HORSHAM DISTRICT COUNCIL CONSULTATION

TO:	Horsham District Council – Planning Dept
LOCATION:	Leonardslee Gardens Brighton Road Lower Beeding West Sussex
DESCRIPTION:	Extension to the visitor entrance building to house a new ticket sales area and café; Infilling roof to the former generator block courtyard, re-roofing of the Alpine House and internal/ external reconfigurations and link extension; Single storey winter garden conservatory to the Stable Block; Terrace extension to the east and internal/ external reconfigurations; Change of use from redundant staff offices and staff accommodation within the stable block to guest accommodation including extension to Honey Cottage; Change of use to the partial first floor of the Red House to staff accommodation; Small WC extension, reinstated chimney stack, and roof alterations to the Engine House; Lightweight wedding pavilion to the lawn, south of Leonardslee House; Landscaping changes including to the forecourt of Leonardslee House.

REFERENCE:	DC/25/1146
RECOMMENDATION:	No Objection / More Information

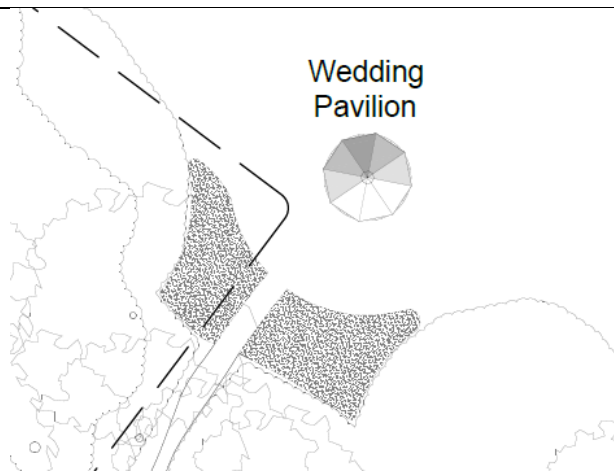
7. Please clarify what the shaded hatch is to the south of the proposed wedding pavilion:
